**ADVANCED GEOTECHNICAL SOLUTIONS, INC.**

Report No. 1310-04-B-6

**Subject:** *Response to City of Santee Review Comments and Geotechnical Third-Party Review, Tyler Street Residential Development, Southeast of Tyler Avenue and Mesa Heights Road, Santee, California*

PRELIMINARY GRADING PLAN  
TYLER STREET PROJECT

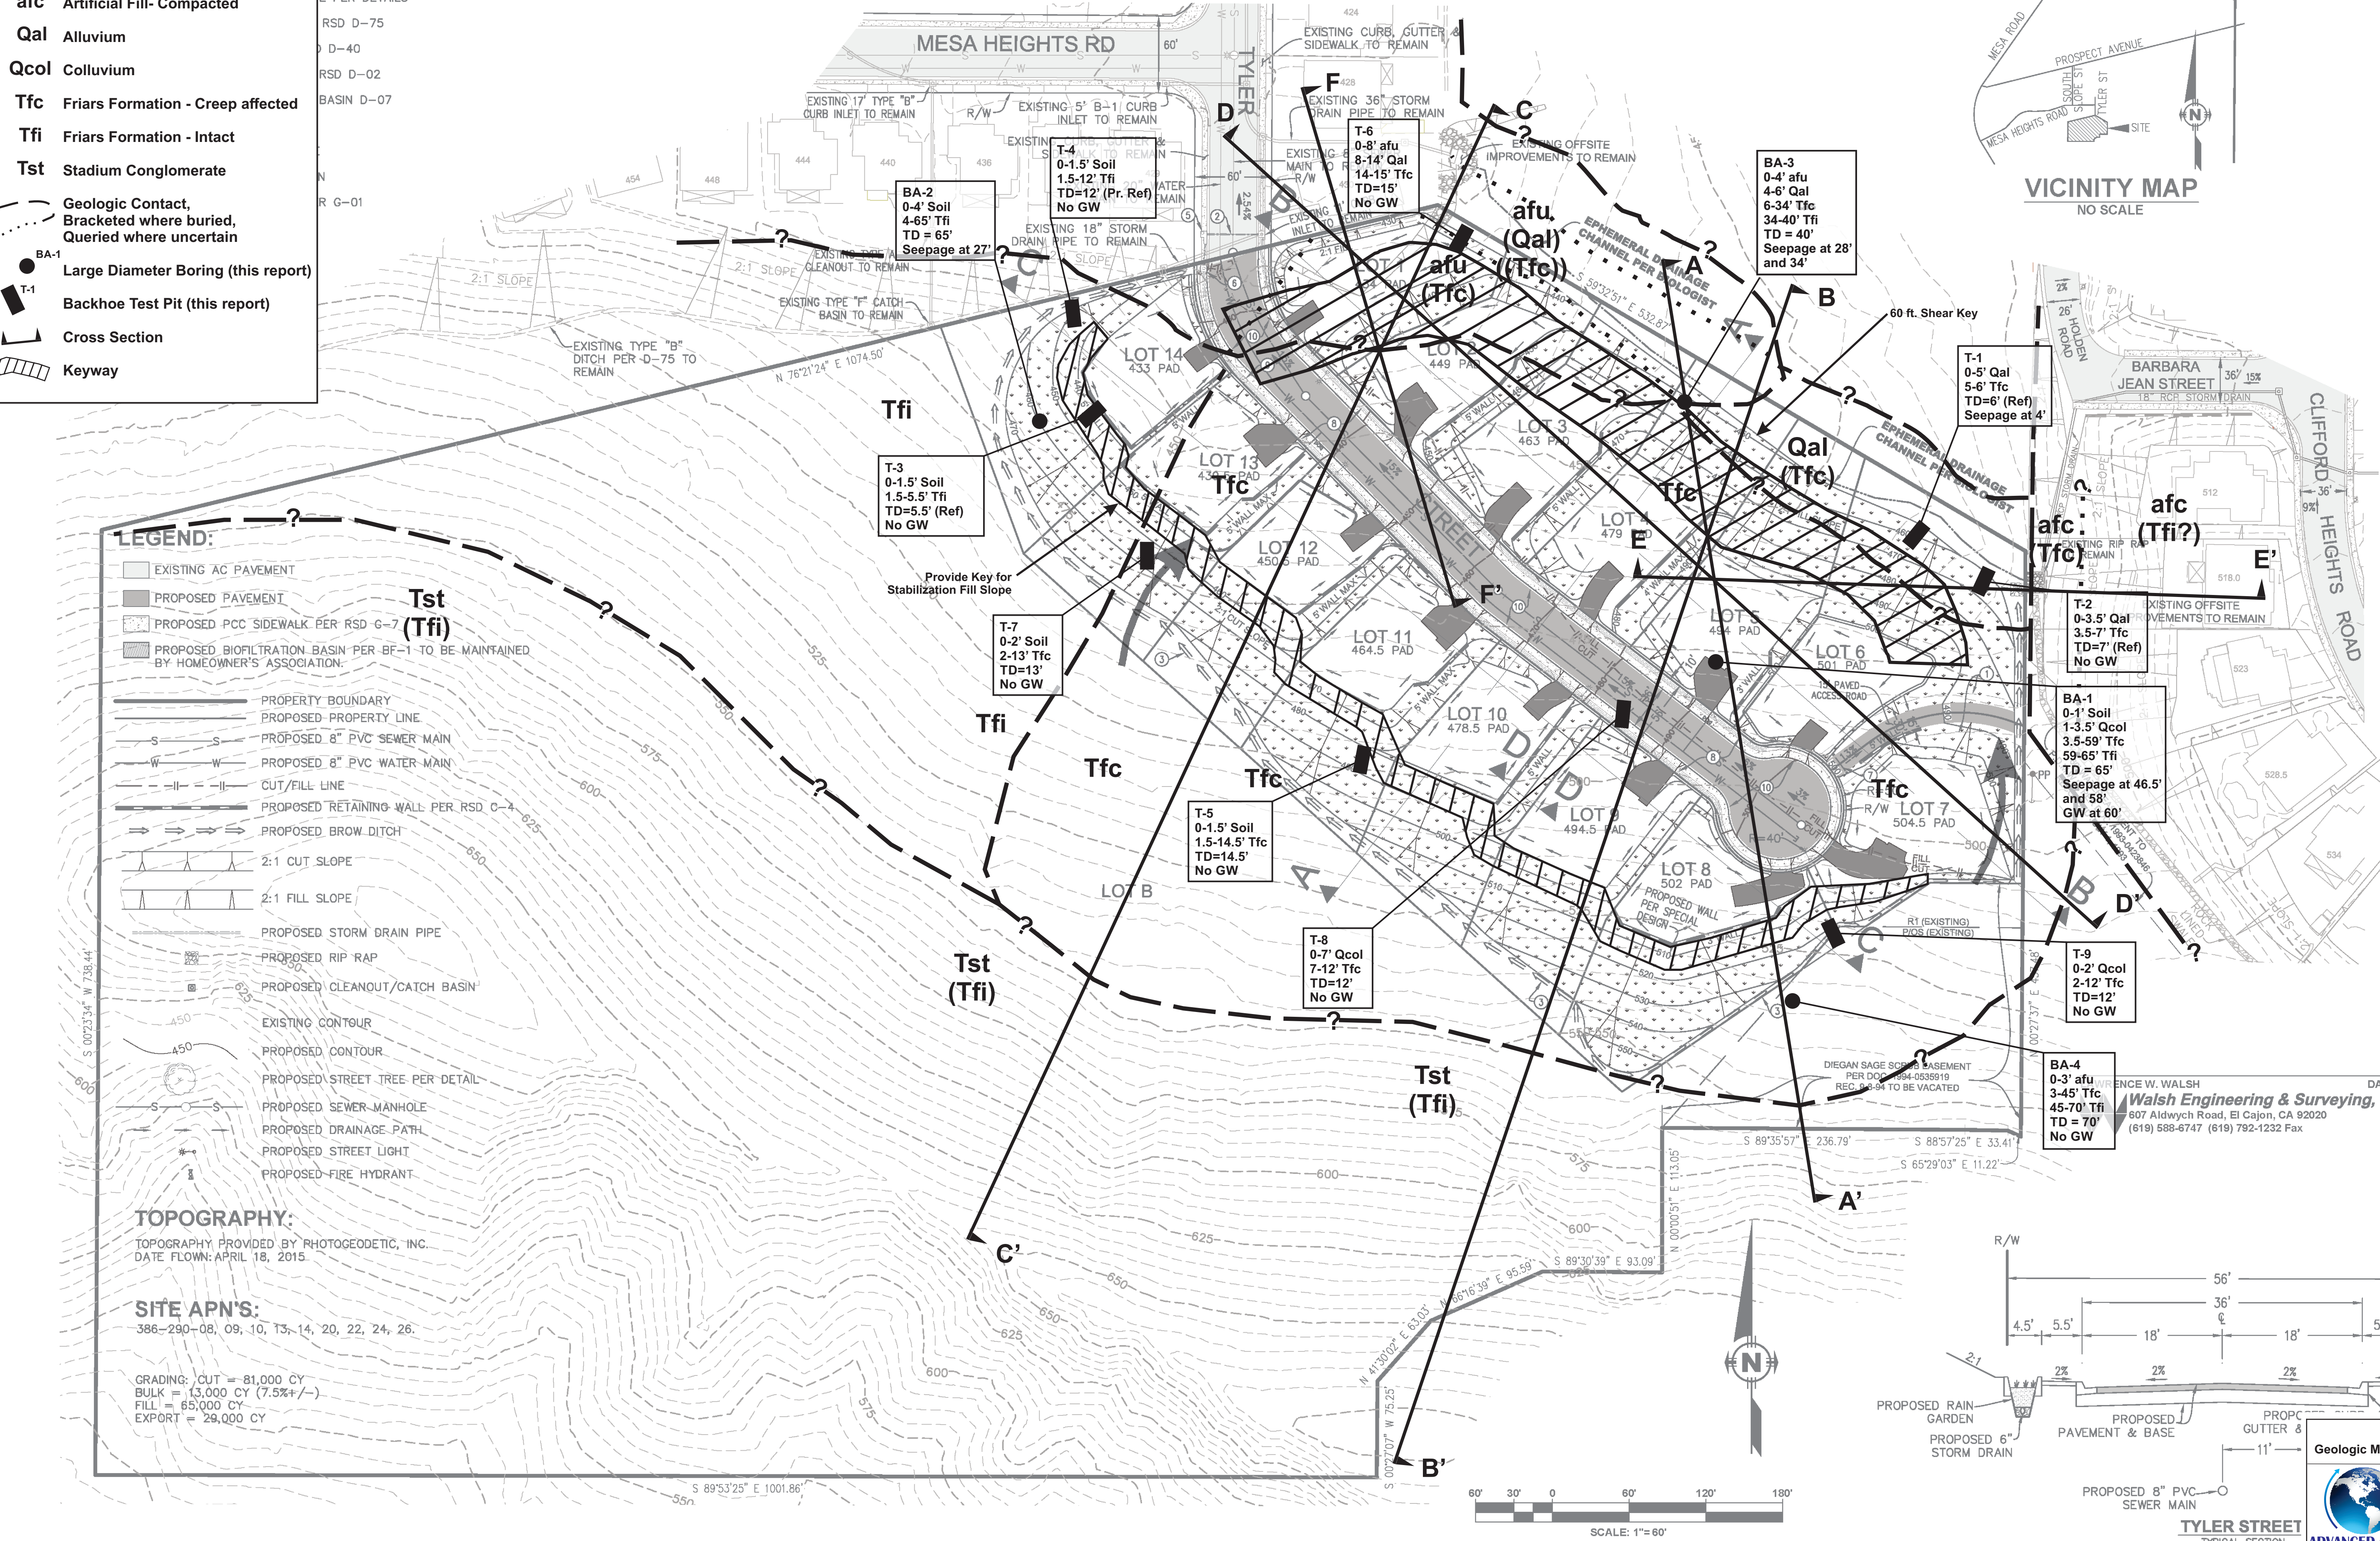
*a. The preliminary grading plan within the geotechnical investigation shall be updated to reflect the most recent design.*

**AGS Response:** 3a. AGS has updated our Geologic Map and Exploration Location Plan (Plate 1) and associated cross sections (Plates 2 & 3) to reflect the current design prepared by Walsh Engineering and Surveying, Inc., dated March 12, 2019. The updated Plates 1 through 3 are attached to our revised geotechnical report (AGS, 2019) included in Appendix B.
